| DETAILED PROJECT REPORT RIO CULEBRAS AGUADILLA, PUERTO RICO | | | |

**DRAFT OF DETAILED PROJECT REPORT AND ENVIRONMENTAL ASSESSMENT
RIO CULEBRINAS, AGUADA-AGUADILLA**

**SUBJECT: Río Culebrinas, Aguadilla-Aguada, Puerto Rico
Draft Detailed Project Report and Environmental Assessment**

Figure 2. Original alternative 1 from Section 205 Reconnaissance Report, 1992.

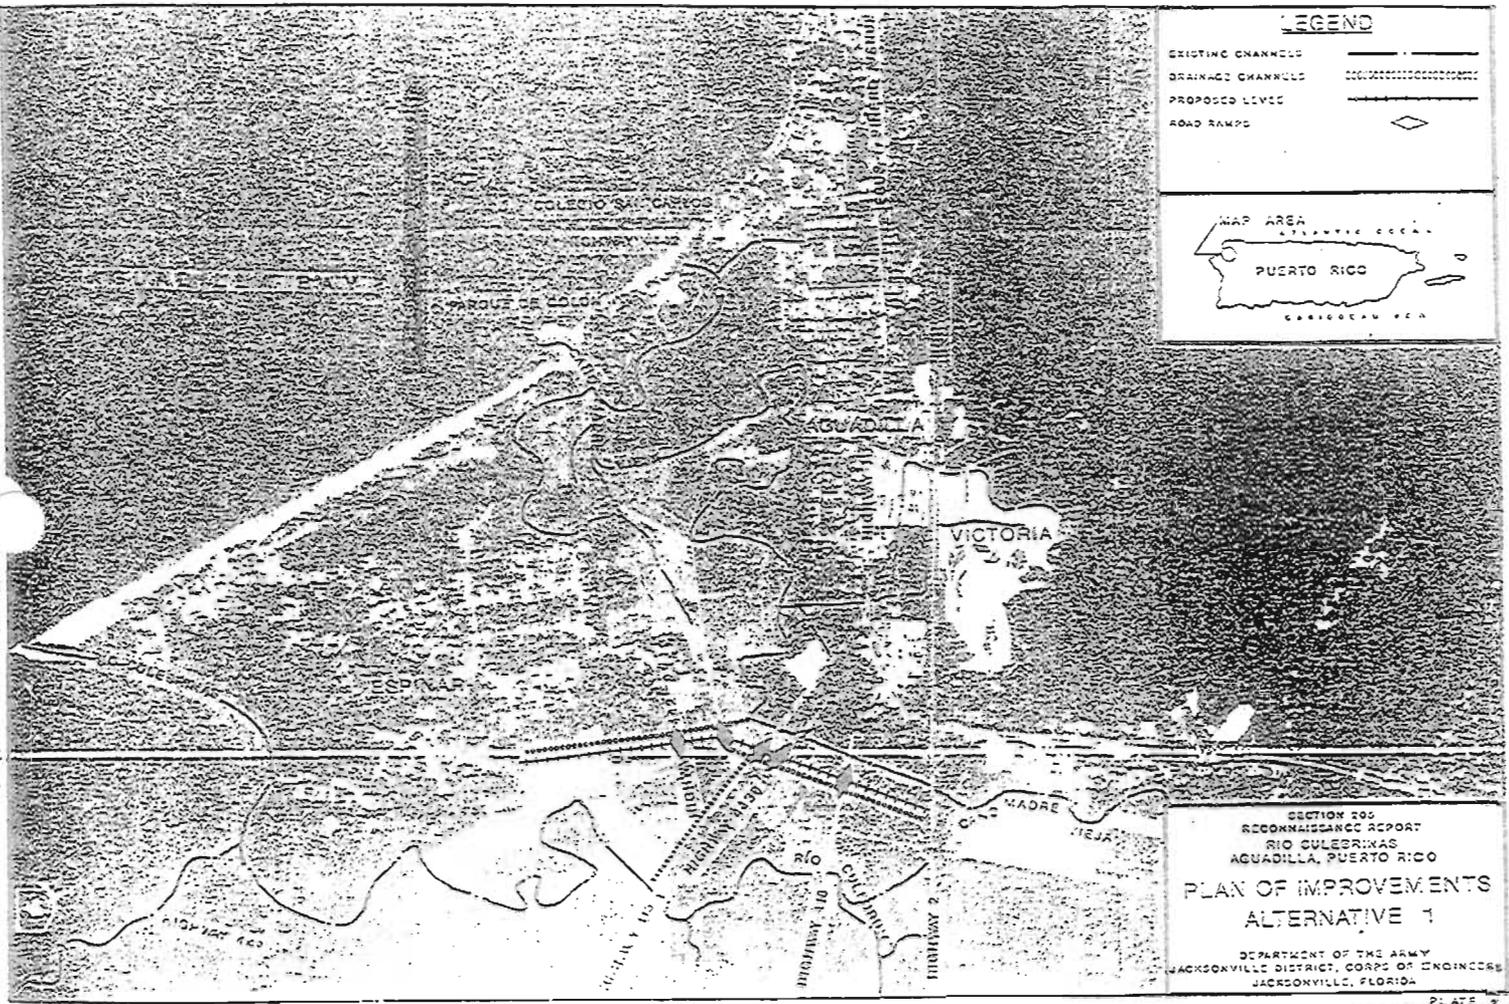
In contrast to the preferred alternative, the alternative to build a single levee would not involve direct impacts to wetlands. Further although the DEA concludes that this levee would have unacceptable impacts on mangrove and herbaceous wetlands associated with Caño Madre Vieja, our evaluation indicates that this conclusion may not be correct. Flood waters from the Culebrinas River reach the

Caño Madre Vieja system only during extreme events so the mangrove system is supported by hydrological factors other than periodic flooding. Thus, we do not believe that the single levee design will change current conditions enough to impact the mangroves. In addition, the proposed single levee includes drainage structures to ensure that water flows between the Culebrinas River floodway and the Caño Madre Vieja system would continue. Accordingly, the NMFS believes that hydrologic alterations will be far greater under the twin levee design due to direct impacts of wetland fill, elimination of a 3,200-foot double meander system, destruction of estuarine wetlands associated with the Caño Madre Vieja channel, the replacement of this channel with a 200-foot-long by 140-foot-wide cut-off channel, and conversion of wetland areas in the protected areas of the levees to drainage channels and ponding areas.

Figure 4. Currently favored alternative with the modified west levee.

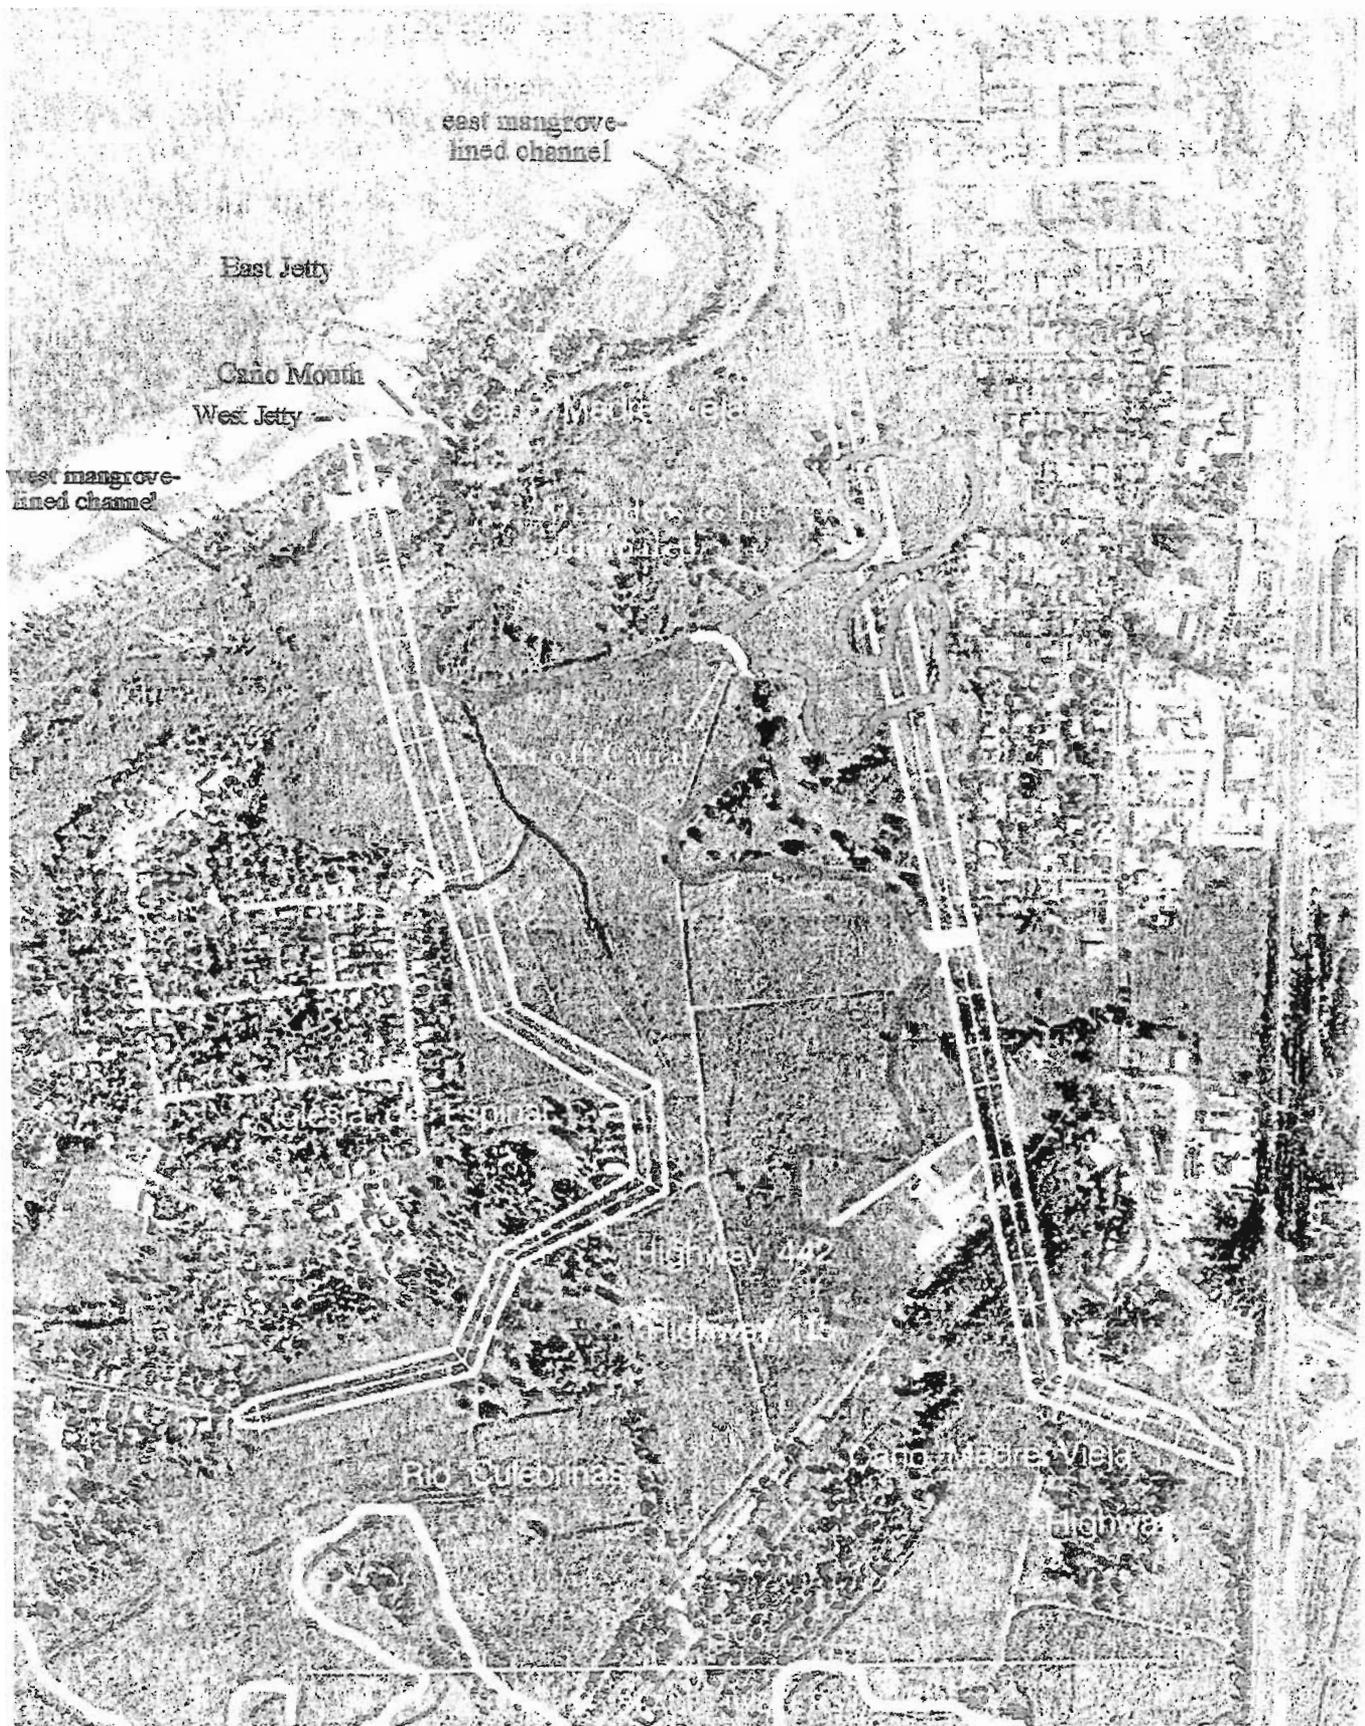
Alternative 2 from the original Reconnaissance Report (Figure 3) would provide two flood levees: one along the eastern side of Caño Madre Vieja north of PR-2 to protect southern Aguadilla, and a flood ring levee on the west side of the Caño. The original design would also have included a continuation of this levee on the north side of Espinar. Various permutations of Alternative 2 have been considered by the Corps as additional alternatives, mostly as variations to the western levee. In addition to the levees, the various permutations of this alternative also require the elimination of a double meander of Caño Madre Vieja via a short cut-off channel to accommodate the eastern levee. A modified version of Alternative 2 is the currently preferred alternative described as "Plan 1" in the Detailed Project Report (Figure 4). The western levee of this plan was altered to include the Iglesia de Espinar, a historic church for that community, in the protected area. The portion of the levee behind the beach berm and just north of Espinar community was eliminated, and the end of the levee was tied into the beach berm on the west side of the mouth of the Caño. One-way drainage structures are to be incorporated into the levee at strategic points. This last alternative has been further modified to include a two-way culvert

to provide hydrology to the mangrove forest channel that runs on the north and east sides of the Espinar community.
